# T ECHNICAL INFORMATION

60857

- Subject** ▶ Change of Replacement Switch
- For Models** ▶ 601D, 6200D, 6201D, 6211D, 6220D, 6221D, 6223D, 6311D, 6400D, 6903VD, 6907D, 6911D, 6911HD, 6913D, 6940D, 6942D, 8411D, BM120, SC120D, SC130D, SC160D
- Country** ▶ All countries
- Description** ▶ In order to prevent wrong wiring, the replacement switch has been changed to the one with a red lead wire. It helps you distinguish the (+) terminal.

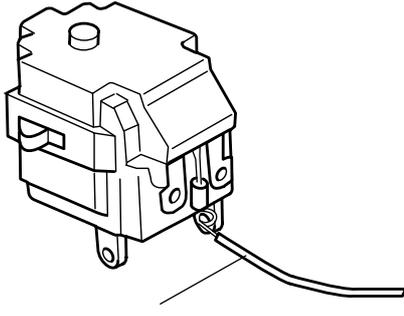
▶ Current	▶ New
 <p style="margin-top: 10px;">(+) terminal</p> <p style="margin-top: 10px;">Switch (Part No. 651909-5)</p>	 <p style="margin-top: 10px;">A red lead wire has been soldered onto the (+) terminal of the switch.</p> <p style="margin-top: 10px;">Switch (Part No. 650500-6)</p>

Item No.	Current part		Q'ty	I/C	New part		Q'ty	Note
See below	Switch 651909-5		1	←	Switch 650500-6		1

Interchangeability mark ; ← means that the new part is substituted for the current.
